CITY PLAN COMMISSION STAFF REPORT

Woodhaven

Item	Case	Request
7	CD-CPC-2021-00216	Rezoning to MPD

Plan Conditions, Corrections, & Recommendations Report

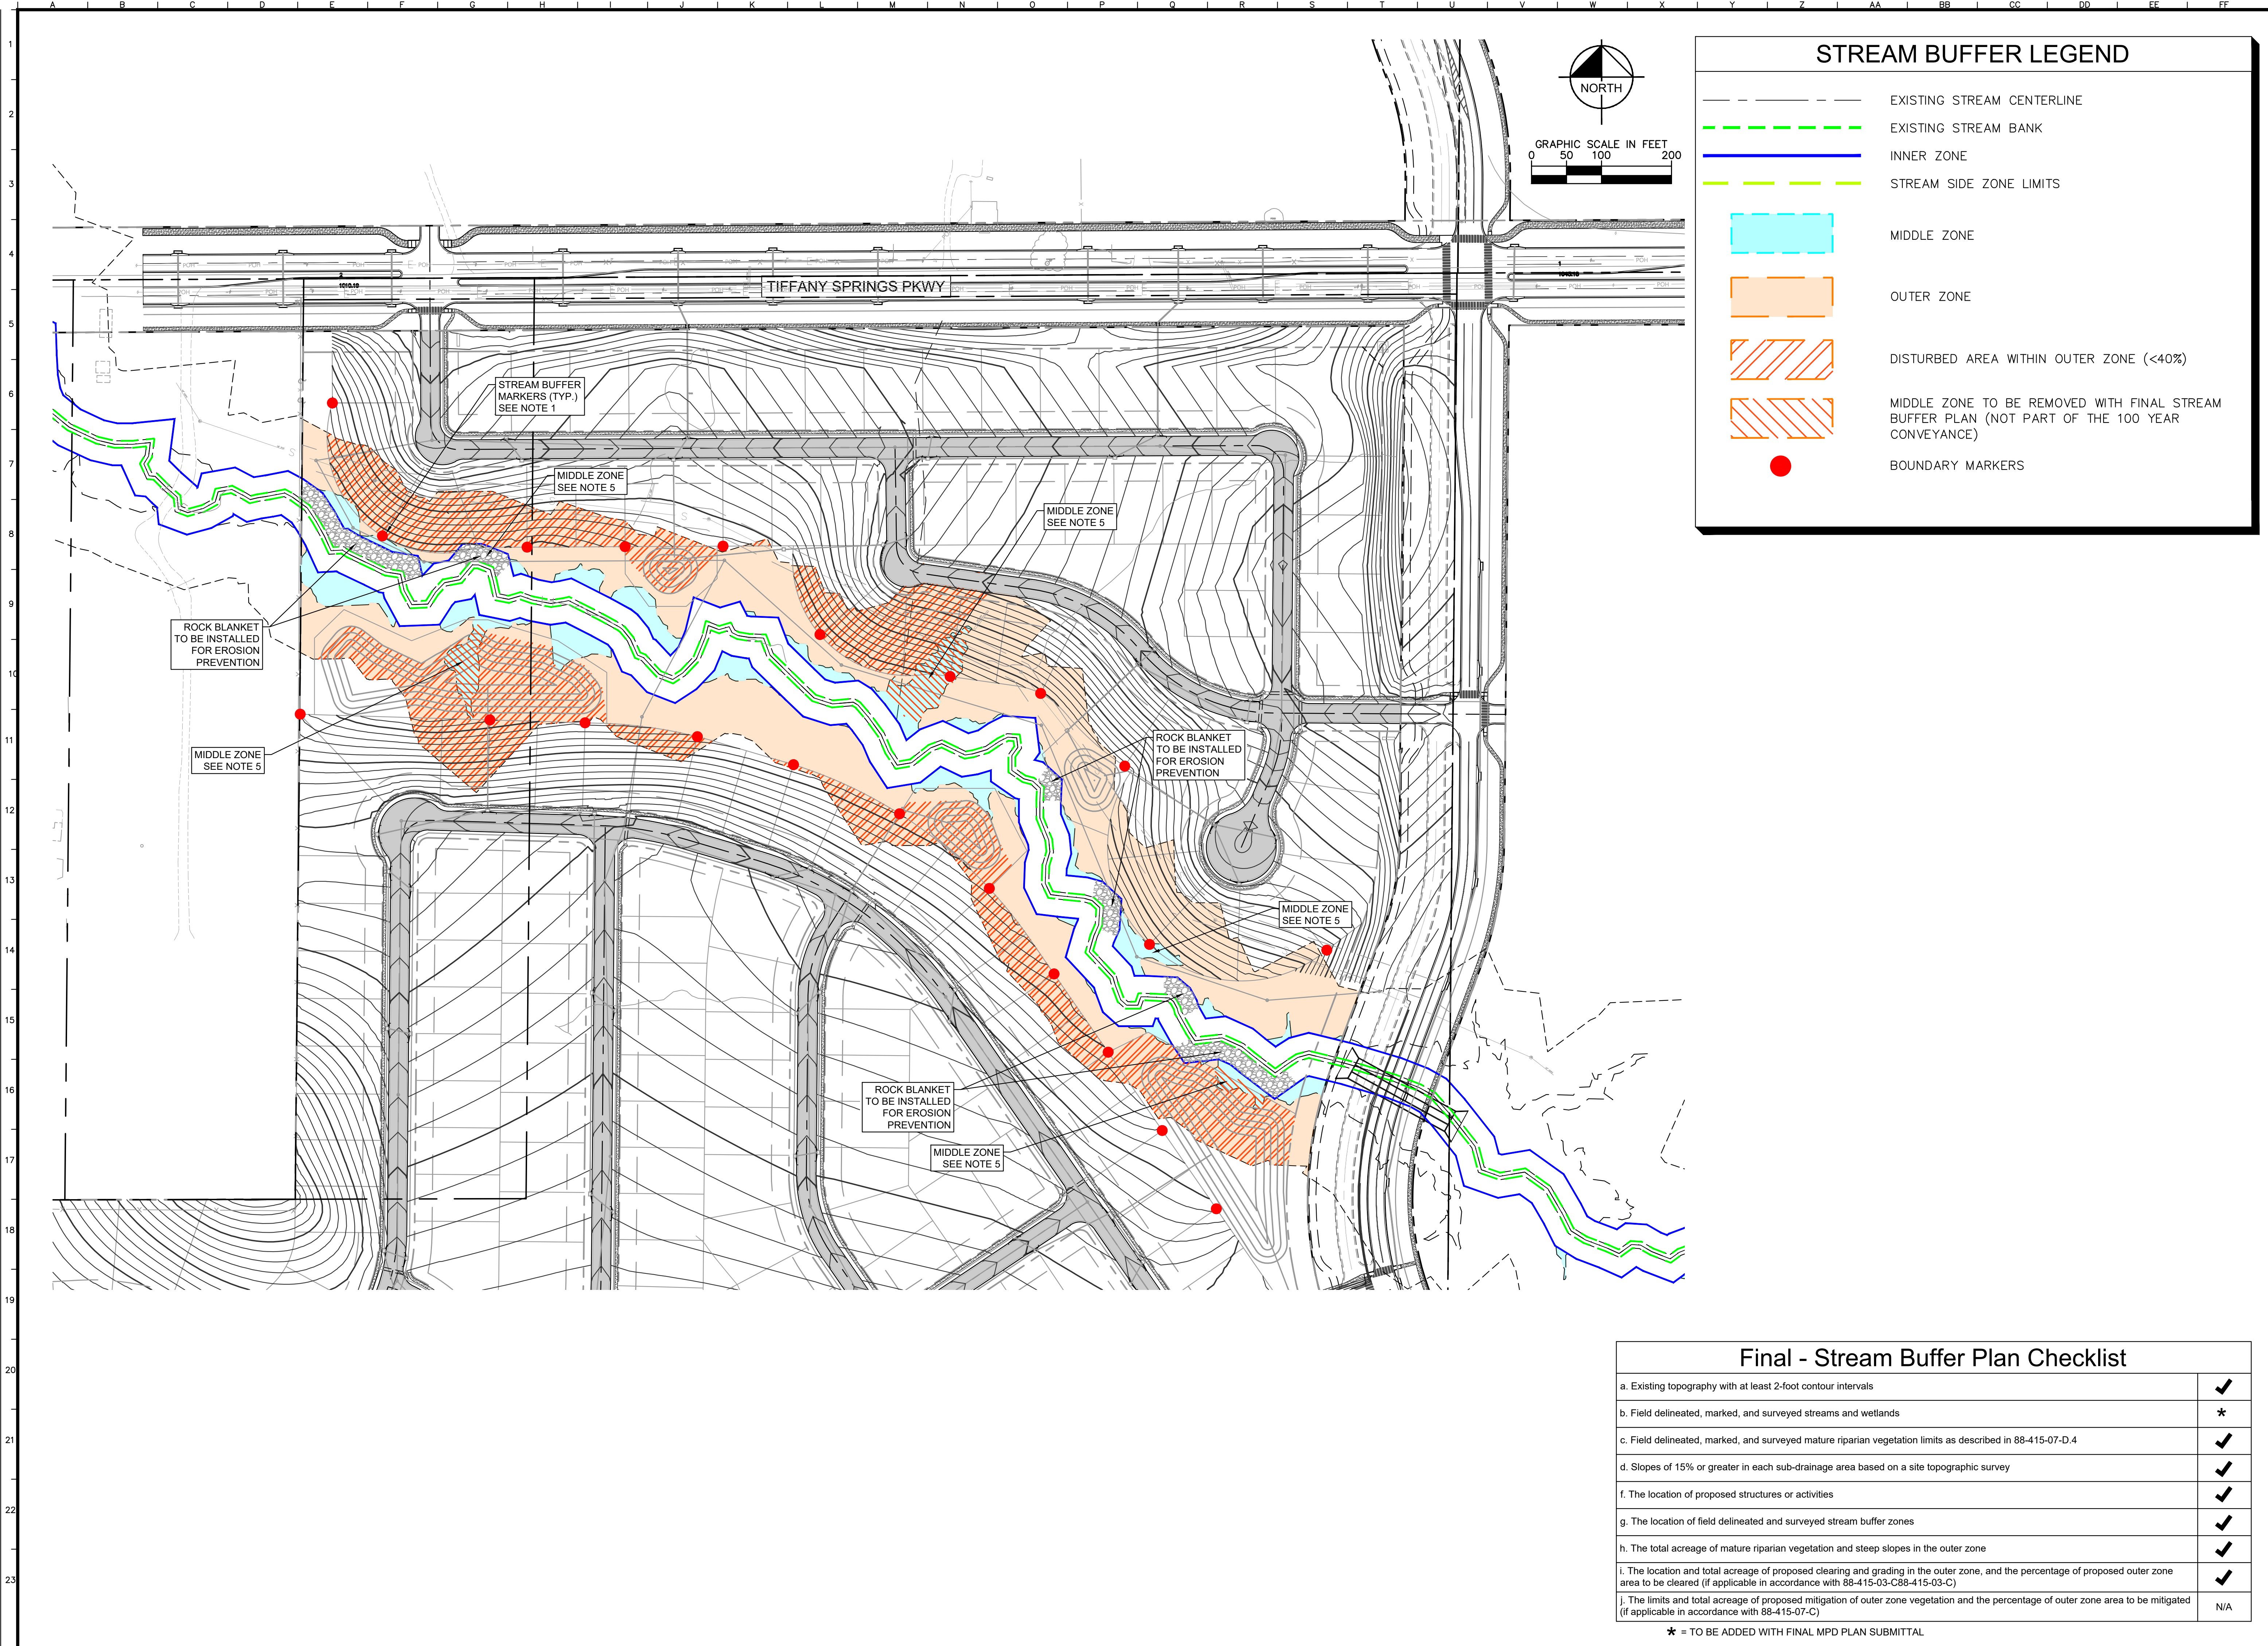
2. Stream buffer plan does not include all of the information required as part of Section 88-415. UPDATED 1/10/22 - no revisions made to the stream buffer plans as part of the resubmittal. (1/03/2022)

11. Stream buffer plans do not meet requirements of 88-415. Fill in middle zone is not allowed except for allowed uses. First twenty-five feet of outer zone is no-build area. There is risk for embankment failures due to proximity of fill slopes to streams--this must be addressed through erosion hazard and slope stability analyses.
Updated Comment (2022-01-12): Fill in middle zone is not allowed for detention ponds. Proposed fill will reduce the natural storage in floodplain areas and could increase flood elevations. Storage in ineffective flow areas helps to attenuate peak discharges downstream, since it is essentially acting as a natural detention area. Provide a minimum of 25 feet (no-build area per 88-415-5-C.2.c) from edge of middle zone to any improvements, including embankment fill. Remove proposed "rock blanket for erosion prevention"--this is not acceptable and in all likelihood will induce stream instability issues. (1/03/2022)
